THM 4L60-E NEW DESIGN SHIFT SOLENOIDS, EPC SOLENOID AND TCC/PWM SOLENOID

CHANGE: Beginning at the start of production for all 1998 models, the THM 4L60-E transmissions were built with a new design for both Shift Solenoids, a new design EPC Solenoid, and a new design TCC/PWM Solenoid.

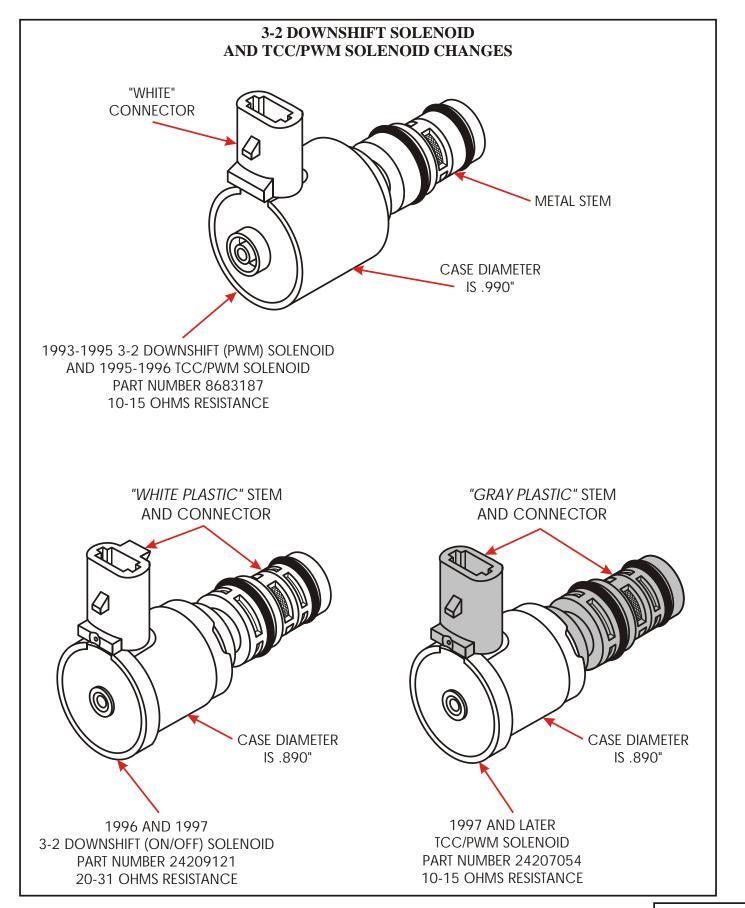
- (1) TCC/PWM SOLENOID Changes from a metal stem to a "Gray Plastic" stem as shown in Figure 1, and the solenoid connector is also Gray in color to help distinguish it from the 3-2 Downshift (ON-OFF) Solenoid. These two solenoids are now manufactured identical, with the exact same dimensions, except for the difference in color of the solenoid stem and solenoid connector. The wide groove to accept the internal harness connector is also on opposite sides of the solenoid connector to prevent the solenoids from being accidentally installed in the wrong models, as shown in Figure 1.

Figure 2
AUTOMATIC TRANSMISSION SERVICE GROUP

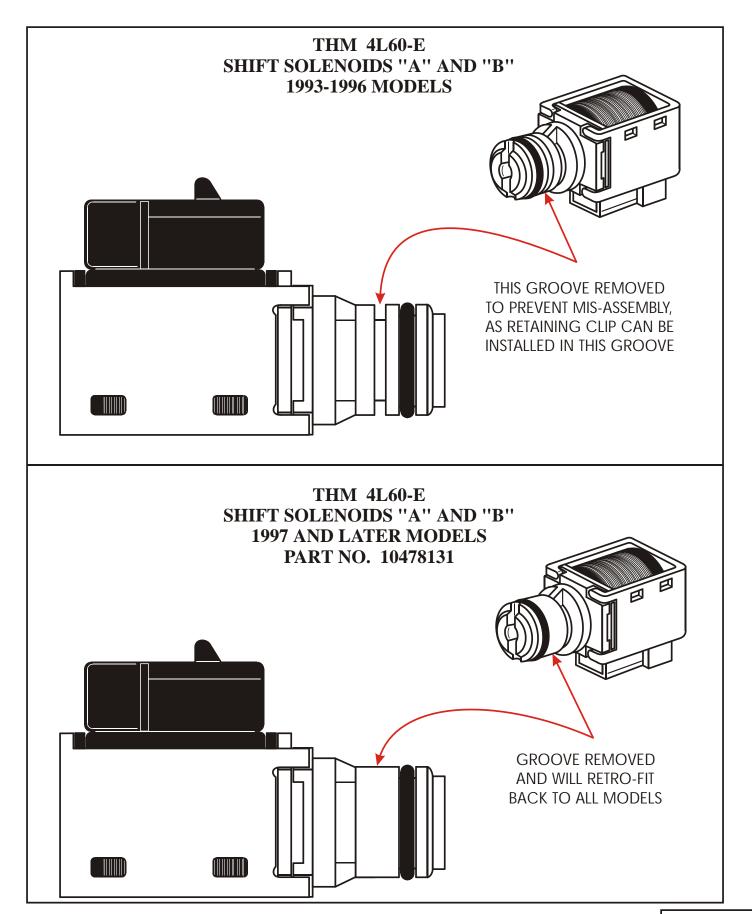
- (2) SHIFT SOLENOIDS "A" AND "B" One groove has been removed from the stem of the Shift Solenoids to prevent mis-assembly concerns, as the retaining clip can be installed in the previous design solenoids, which means the solenoid is not all the way into it's bore. Refer to Figure 2.

Figure 3
AUTOMATIC TRANSMISSION SERVICE GROUP

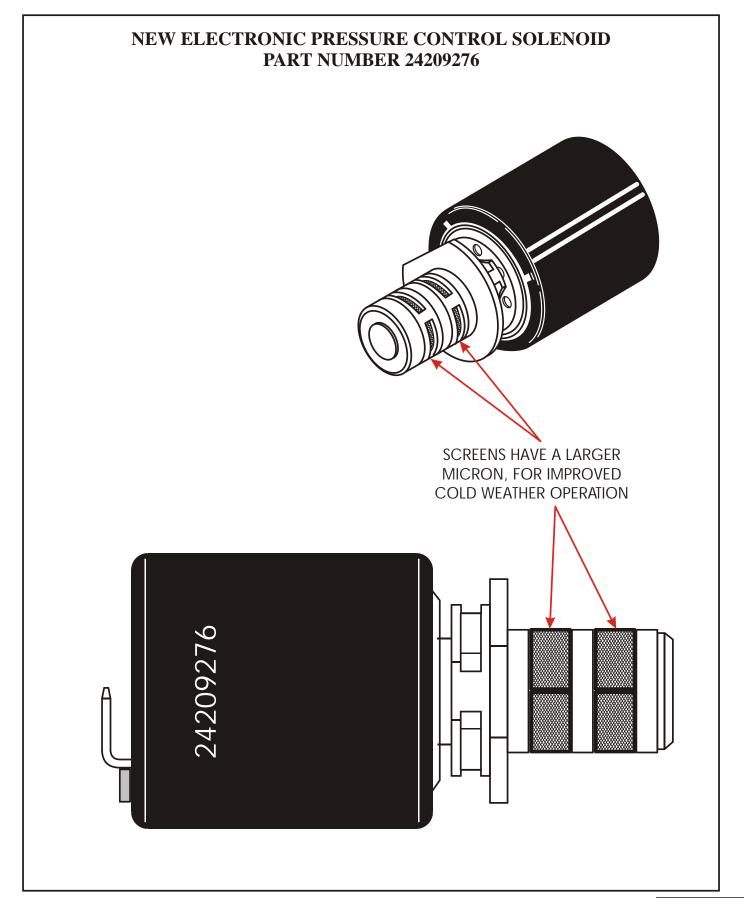
- (3) PRESSURE CONTROL SOLENOID New design has larger micron screens in the solenoid to greatly improve cold weather operation. This will allow the colder oil through the screens easier. Refer to Figure 3.
